UNITED STATES PATENT AND TRADEMARK OFFICE

APPLICATION NO.	FILING DATE	FIRST NAMED INVENTOR	ATTORNEY DOCKET NO.	CONFIRMATION NO.
09/678,414	10/02/2000	David W. Carlson	NSC1-H1700 [P04797]	4381
33402	7590	11/08/2006	EXAMINER	
LAW OFFICES OF MARK C. PICKERING P.O. BOX 300 PETALUMA, CA 94953			KEBEDE, BROOK	
			ART UNIT	PAPER NUMBER
			2823

Office Action Summary	Application No.		Applicant(s)	
	09/678,414		CARLSON, DAVID W.	
	Examiner		Art Unit	
	Brook Kebede		2823

DETAILED ACTION

**FIG. 2D**

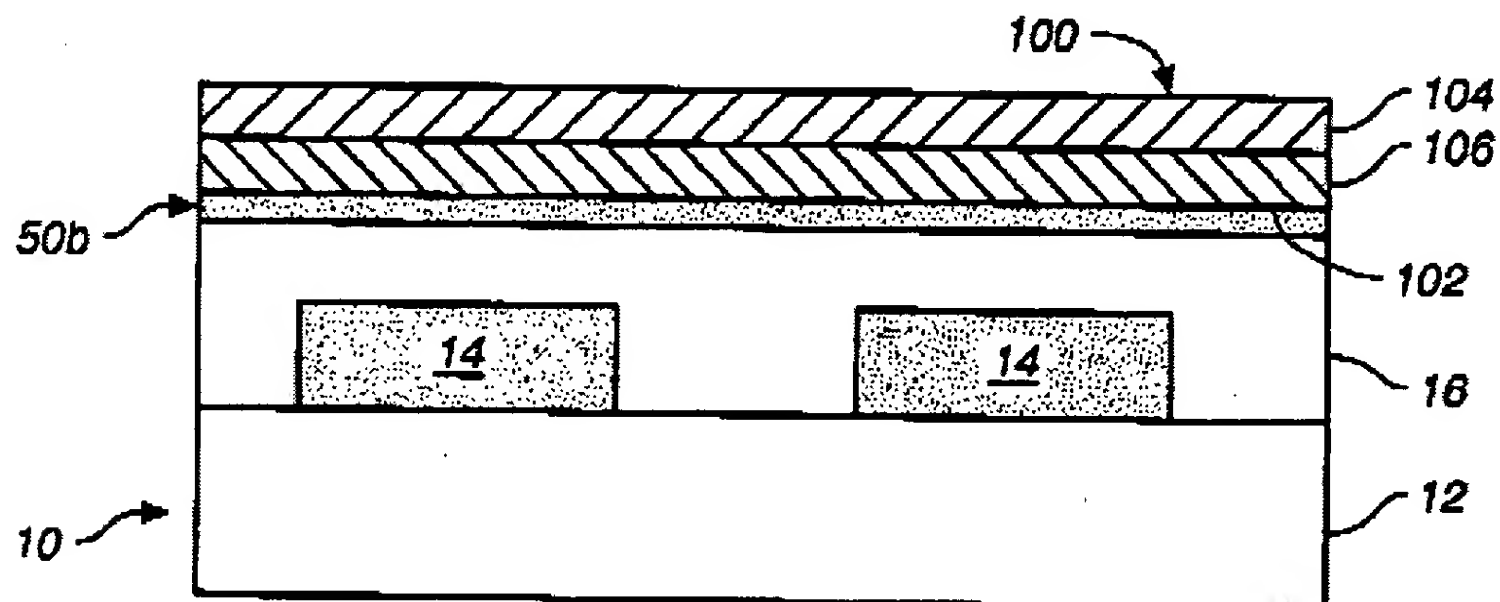
In response to the applicant's argument, it is respectfully submitted that Li et al. '368 disclose all the claimed limitations the instant application as claimed in claims 31-36, 38-46 and 49-52 as applied above. For example, as shown in Fig. 2D and presented herein below, the first material layer 16 does actually polished to have planar surface prior layer 50b , 106 and 104 are deposited. The removal of the second material layer 18 and planarizing of the second material

16 is happened concurrently within short period of time by CMP process (see also Col. 6, lines 1-5). In addition, with respect to applicant's argument, it is not clear how could be possible that polishing of layer 16 with out removing of layer 18.

**FIG. 2G**

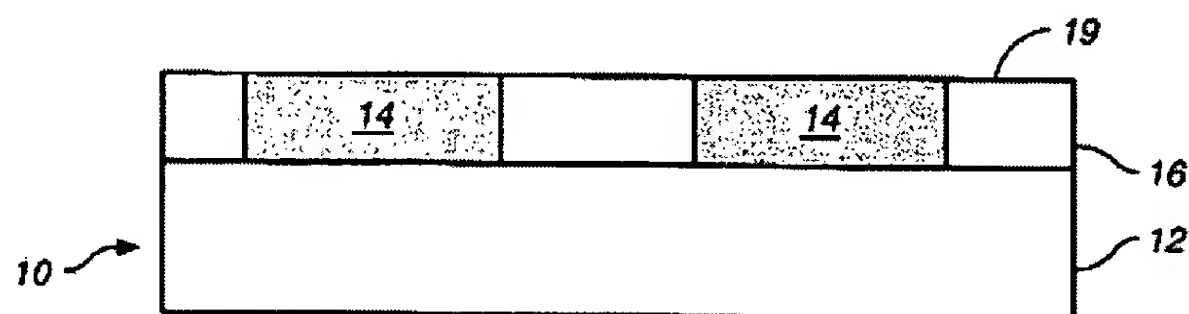
After the CMP process and removal of the material layer 18, the first material layer 16 having a substantially planar surface 19 as shown in Fig. 2G herein below.

Further in response to applicant's contention, it is respectfully submitted the instant application claimed invention does not specifically disclose to the degree of certainty that instant application CMP process will result a perfect planar surface that cannot be achieved by the CMP

FIG. 2I

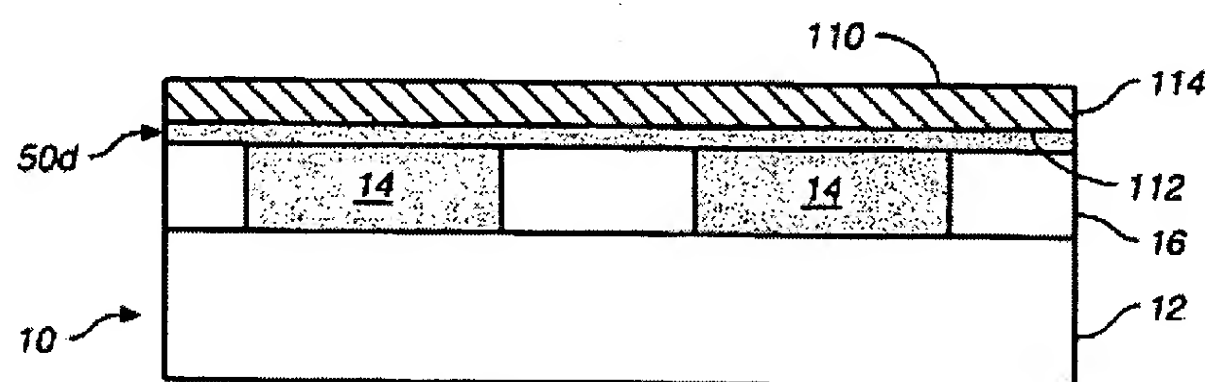
In repose to applicant's argument, it is respectfully submitted that Li et al. '368 disclose all the claimed limitations of the instant application as claimed including forming of third material over the planarized second material 16. For example, Fig. 2I as shown below material layer 114 is meets the claim language third material layer as applied in the rejected claims in Paragraph 4 above.
